# Access Compliance Report

## Public Rights-of-Way

Intersection ID: 50485	Main Street: JONES_CROSSING_RD	Cross Street: HAWFIELD_WAY_DR	Location: NE
ADA ID: F65992BB7055	Ramp Type: PerpDiag	Initial Pass/Fail: Fail	Overall Compliance: No
Severity Score: 21.25			
Codes/Mitigation Info/Possible Solution		Field Measurements/Component Compliance

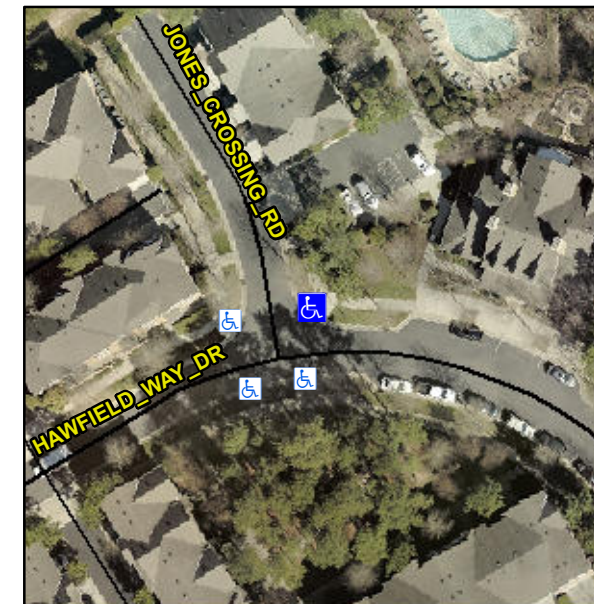
**R304.5.1, R304.5.3**

Compliance	Description	Data	Compliance	Description	Data
N/A	Ramp Length (in)	172.0	Yes	Ramp Slope (%)	5.7
No	Ramp Width (in)	47.5	No	Ramp XSlope (%)	5.6
N/A	Flare Type LT	N/A	N/A	Flare Type RT	N/A
N/A	Flare Slope LT (%)	N/A	N/A	Flare Slope RT (%)	N/A
N/A	Flare Traversable LT?	N/A	N/A	Flare Traversable RT?	N/A
N/A	Landing Length (in)	N/A	N/A	DWS Provided?	N/A
N/A	Landing Width (in)	N/A	N/A	DWS Contrast?	N/A
N/A	Landing Slope (%)	N/A	N/A	DWS Length (in)	N/A
N/A	Landing X Slope (%)	N/A	N/A	DWS Full Width?	N/A
N/A	Landing Curb? (Y/N)	N/A	N/A	DWS Offset (in)	N/A
N/A	Shared Landing?	N/A			
N/A	Gutter Ponding?	N/A	N/A	Gutter Slope (%)	N/A
N/A	Gutter Lip Ht (in)	N/A	N/A	Gutter X Slope (%)	N/A
N/A	Painted X Walk1?	No	N/A	Painted X Walk2?	No
	X Walk 1 Direction	To W		X Walk 2 Direction	To S
N/A	X Walk 1 Width (in)	N/A	N/A	X Walk 2 Width (in)	N/A
	X Walk 1 Slope (%)	4.7		X Walk 2 Slope (%)	1.4
	X Walk 1 X Slope (%)	1.0		X Walk 2 X Slope (%)	4.4

**Remove & Replace Curb Ramp With Two New Directional Ramps or Equivalent.**
